Chief Logan State Park
Museum Roof Replacement

DNR213078

Addendum No. 1

Dated: March 22, 2013

CARLISLE SecurEdge 300

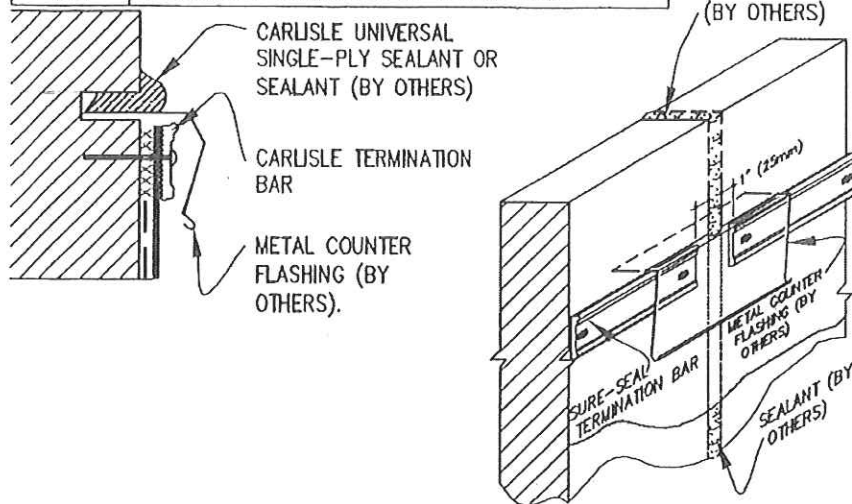
8. Coping shall be installed using SecureEDGE 200 by Carlisle Syntec Systems or approved equal. Edging shall be SecureEDGE 300 by Carlisle Syntec Systems or approved equal. All terminations and copings shall be installed according to the manufacturer's specifications.

9D MECHANICAL TERMINATION

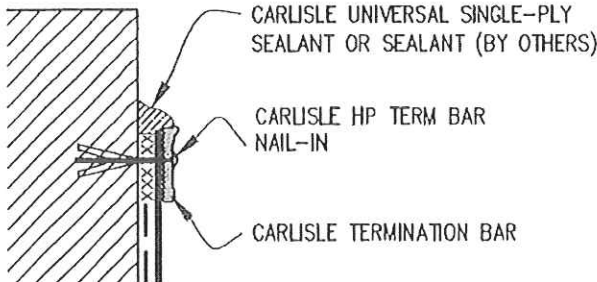
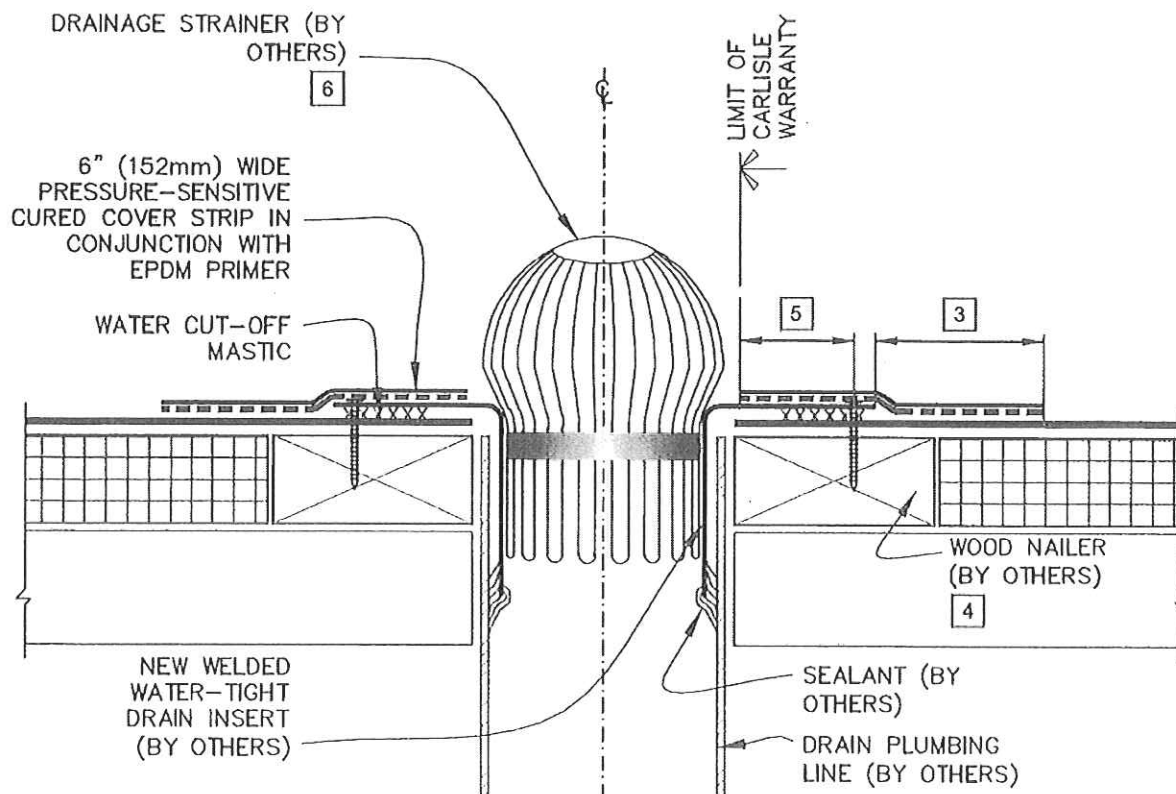
9. The flashing shall be replaced where the flat decked roof meets the front wall on the gable end of the concave roof section. Any water soaked insulation shall be replaced. Include in the base bid the assumption that 100 square feet of 1 inch thick SecureShield HD insulation or approved equal will need to be replaced. Approximately 3 foot by 60 foot of 60 mil EPDM Carlisle Sure-Seal Adhered or approved equal membrane will be necessary for this replacement. Along the vertical wall the installation shall follow the mechanical termination specification 9D on drawing

DETAIL NO.
U-13C

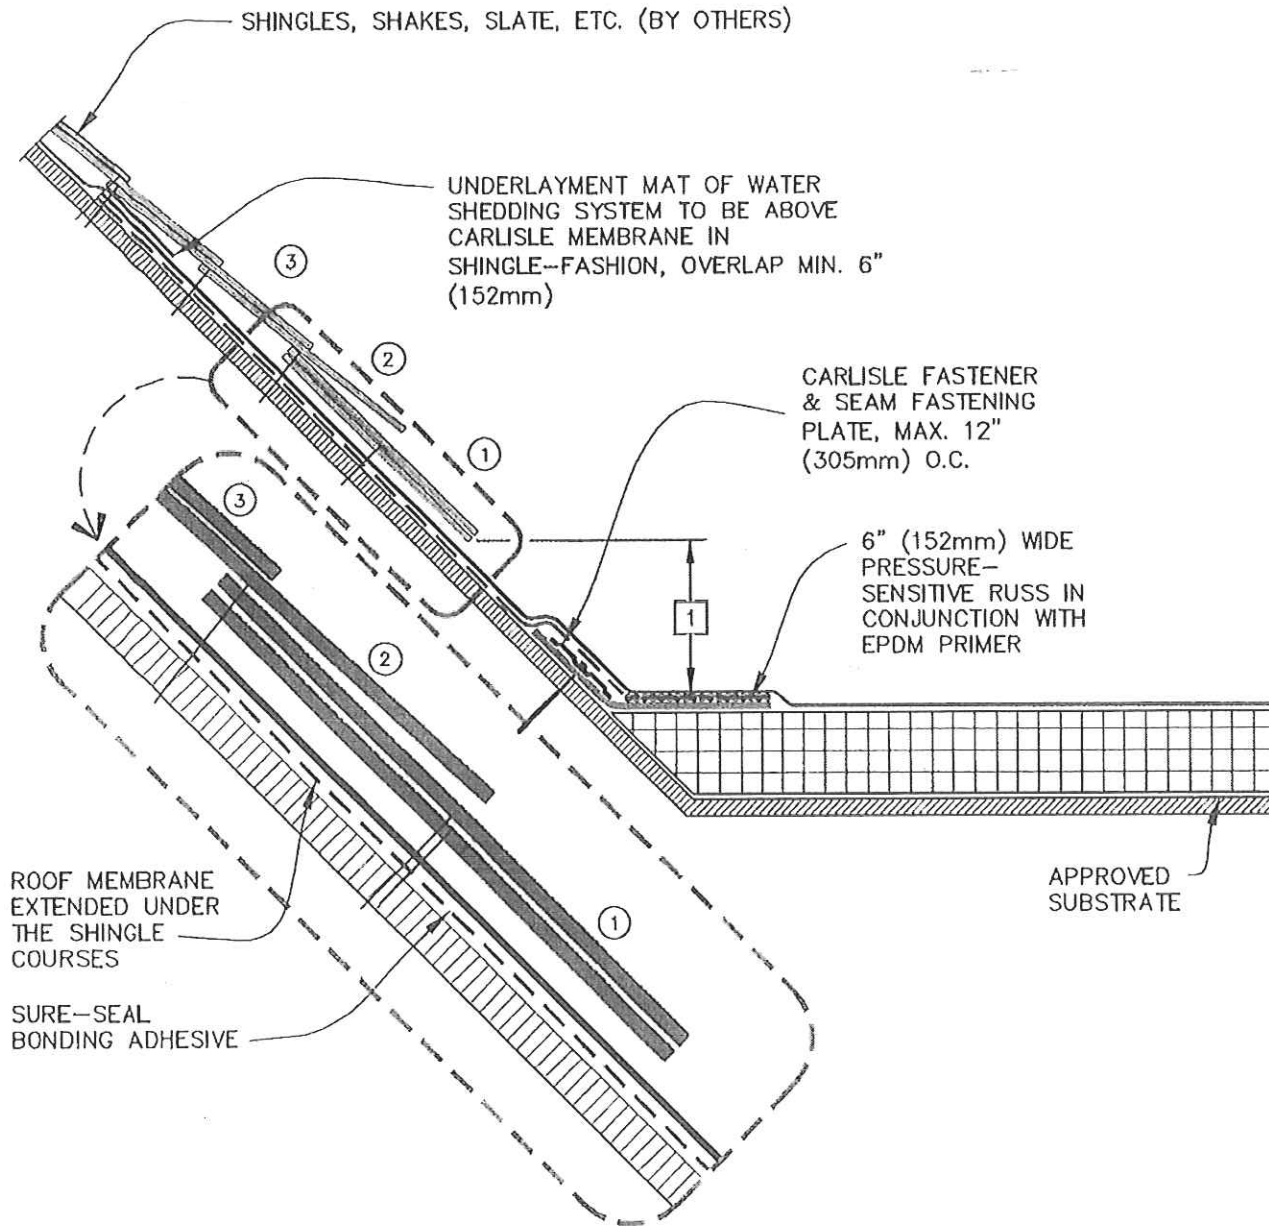
detail No. U-9. Where the new EPDM membrane is to be attached to the old EPDM membrane Detail No. U-13C shall be followed.

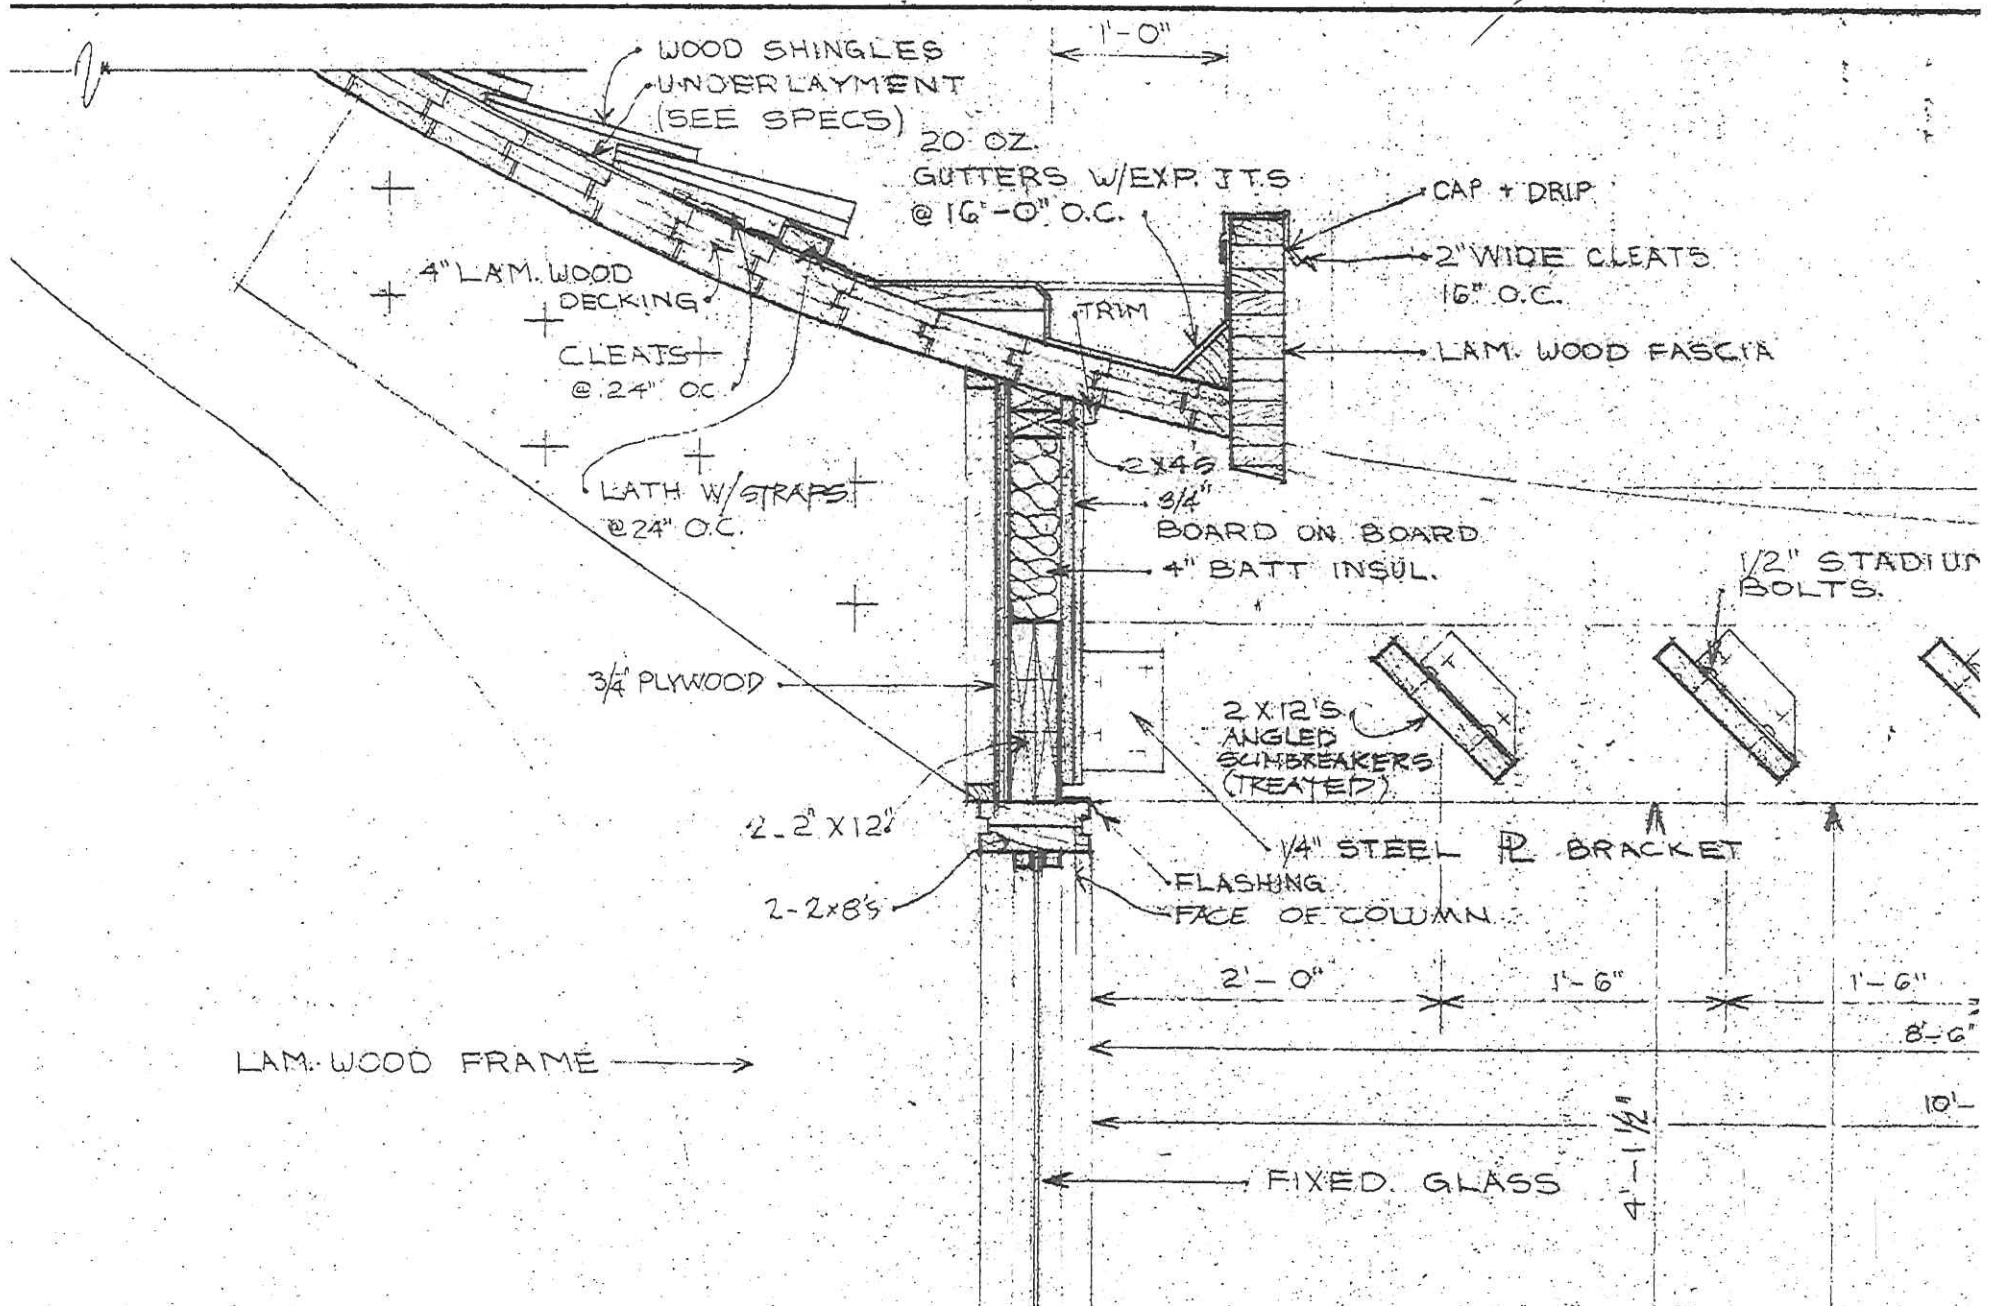
3. The 60 mil EPDM Carlisle Sure-Seal Adhered or approved equal membrane shall extend under the first 3 courses of shingles. Please install according to the attached detail U-13E.
